**Re: Terasen Gas Inc. ("Terasen Gas")
Application for a Certificate of Public Convenience and Necessity ("CPCN") for
the Fraser River South Arm Crossing Upgrade (the "Application")
Response to the British Columbia Utilities Commission ("BCUC" or the
"Commission") Information Request ("IR") No. 1**

Terasen Gas Inc. ("TGI", "Terasen Gas" or the "Company") Application for a Certificate of Public Convenience and Necessity ("CPCN") for the Fraser River South Arm Crossing Upgrade (the "Application" or the "Project")	Submission Date: December 19, 2008
Response to British Columbia Utilities Commission ("BCUC" or the "Commission") Information Request ("IR") No. 1	Page 1

Figure 4-5

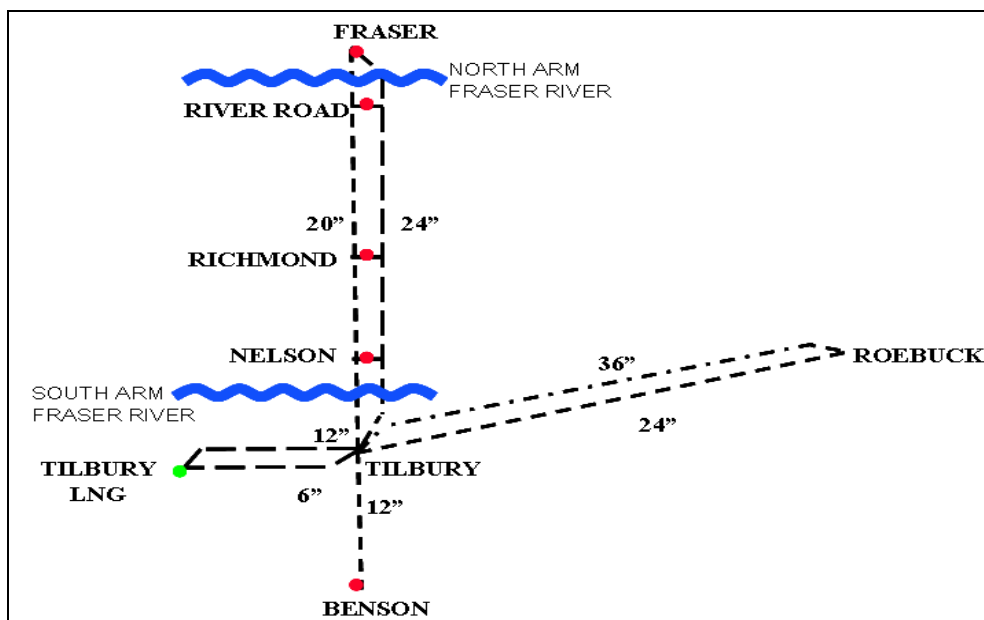
4.5 Please provide a list of the pipelines and their sizes that currently are connected to each of Tilbury Gate and Nelson Gate.

Figure 4-5 shows the pipelines and their sizes that are currently connected between Tilbury Gate to Nelson Gate to Fraser Gate.

Pipelines that are interconnected at Tilbury Gate are:

- ROEBUCK TILBURY NPS 24
- ROEBUCK TILBURY NPS 36
- TILBURY LNG PLANT NPS 6
- TILBURY LNG PLANT NPS 12
- TILBURY BENSON NPS 12
- TILBURY FRASER GATE NPS 20
- TILBURY FRASER GATE NPS 24

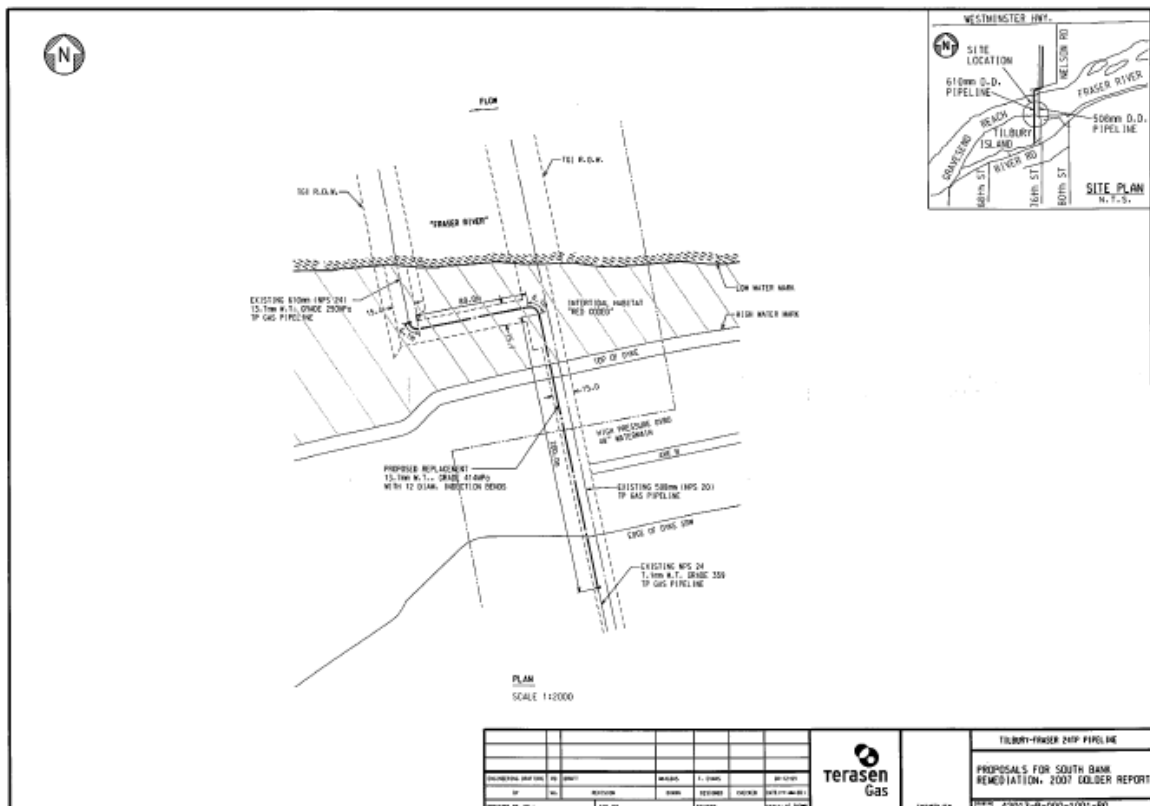
- 8.4 Please provide diagrams illustrating the on-shore work at the north and south banks of the river that is recommended by Golder in their 2007 report, and a cost estimate for the work that would be involved.

The following diagram refers to the proposed remediation measures of the South Bank of the Fraser River from the 2007 Golder Report as referenced in Exhibit B-1. The cost for this proposed South Bank remediation is estimated at \$1.3 million.

It should be noted that after further assessment the Company is of the view that the proposed 2007 Golder remediation measure is not appropriate because it will not withstand ground motions having a mean return period of 2,475 years, predicted from 4th generation seismic hazard mapping. As recommended by Golder in their 2008 report, HDD pipeline replacement is considered the only suitable rehabilitation technique for either or both pipelines.

Attachment 1.3

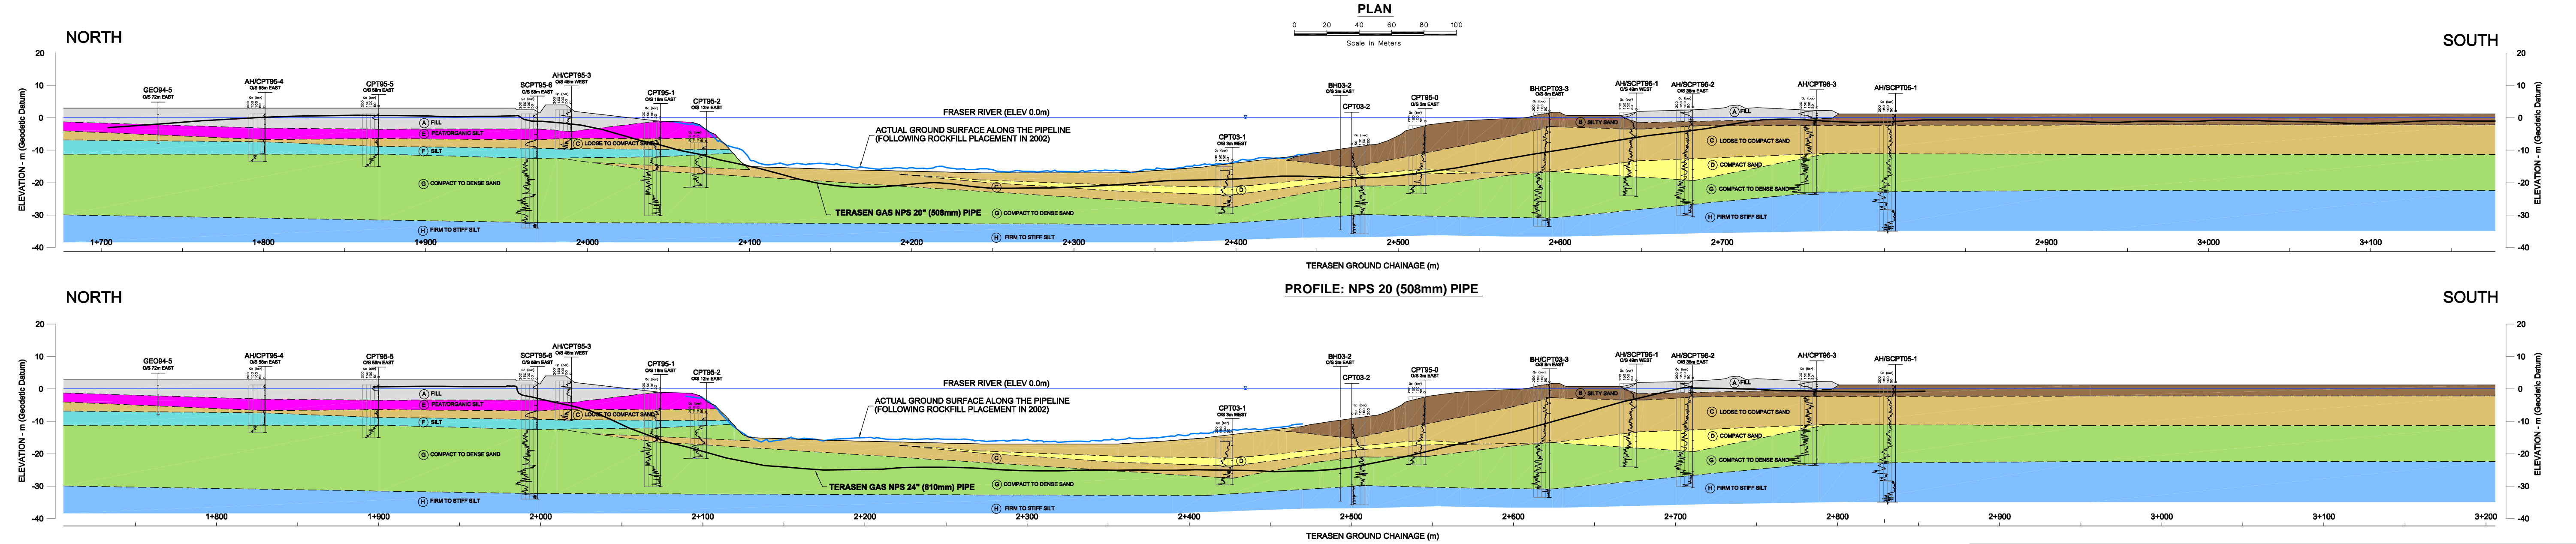
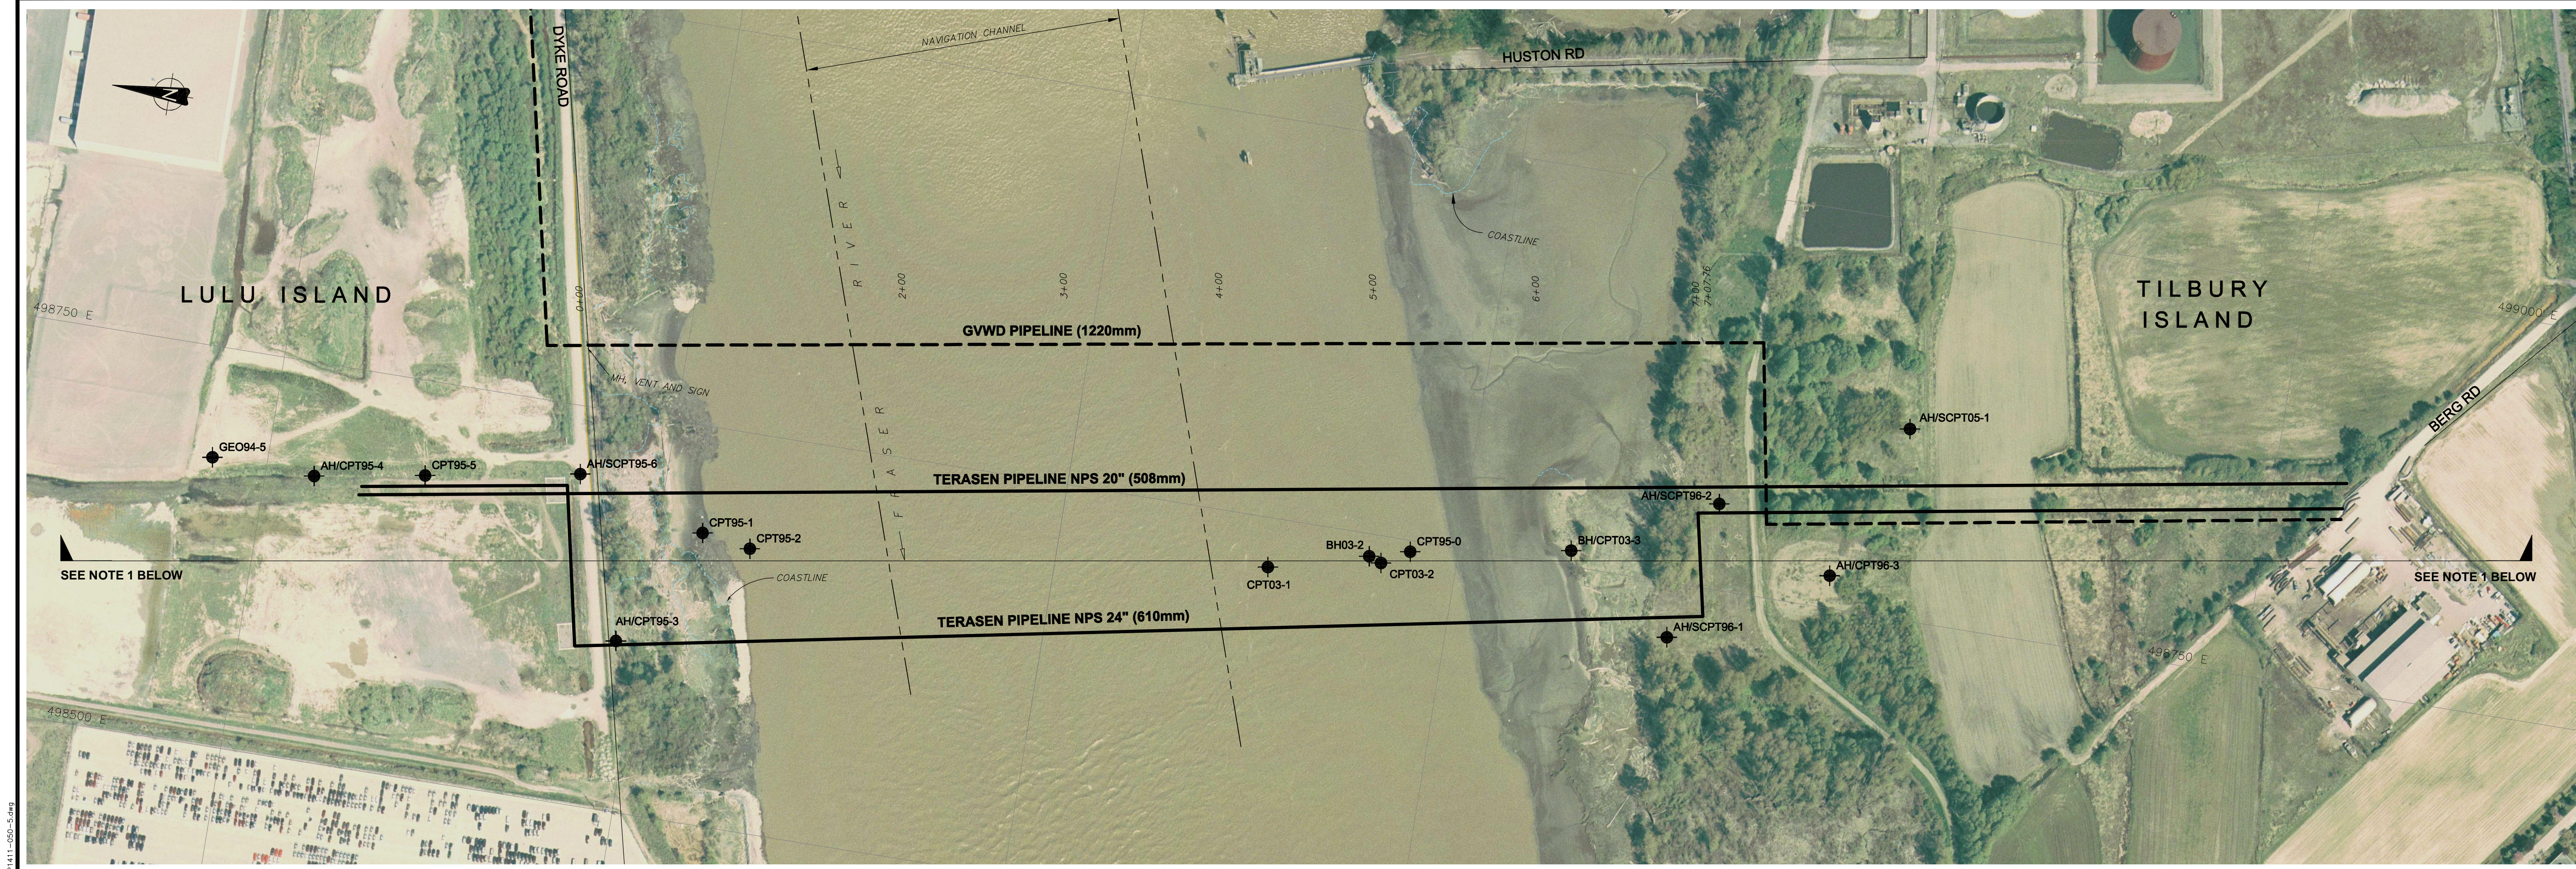
- 1.3 Further to the statement on page 9 that a strong earthquake will likely leave the existing pipelines unsupported, and Appendix 3, please explain why the new HDD crossings will not be at a similar risk of failure. Please include a diagram showing the depths of the existing lines and the proposed depths of the HDD crossings in the response.

10.1 Further to Figure 2-1 in Appendix 3, please provide larger scale forms of this Figure, in at least 11 x 17 size.

10.2 Please provide a large scale diagram similar to Figure 2-1 that shows the existing NPS 20 and NPS 24 pipelines, and also the proposed NPS 20 and NPS 24 pipelines, in both Plan and Profile.

The new HDD crossings will avoid all areas subject to loss of soil support in an earthquake. As shown on the profile drawings included in Attachment 1.3, the new HDD crossings will pass under the river and its banks through firm to stiff soil material, at depths where liquefaction will not occur in a design seismic event. On land, the new crossings will transition back to standard depth approximately 300 m inland from the river banks, beyond the predicted zone of lateral spread. Appendix 5, Golder's 2008 Report – Figures 6-9 and 6-10, show the extent of potentially liquefiable soils.

A large-scale diagram is provided in the response to BCUC IR 1.1.3, Attachment 1.3.

A large-scale diagram is provided in the response to BCUC IR 1.1.3, Attachment 1.3.
